IREDELL COUNTY HEALTH DEPARTMENT

IMPROVEMENT PERMIT / AUTHORIZATION TO CONSTRUCT / OPERATION PERMIT / EXISTING SYSTEM INSPECTION

PERMIT# 033748 PIN# 4894 00 3230 (PART) DATE 10-20-99

INITIAL SITE SKETCH

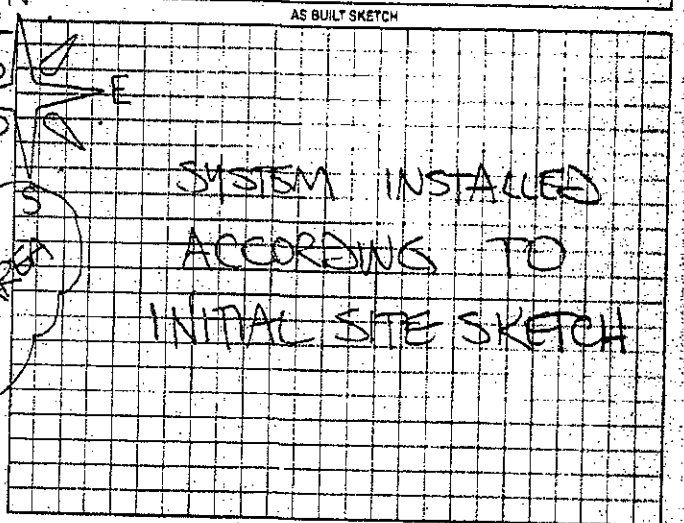
Comments/Conditions: KEEP SYSTEM MINIMUM 100 FEET FROM WELL ② INSTALL LINES ON CONTOUR AS FLAGGED, NO DEEPER THAN 30 INCHES.

Comments/Conditions: SEPTIC TANK WITH RISERS AND MARKER INSTALLED USING "ZABEL" FILTER
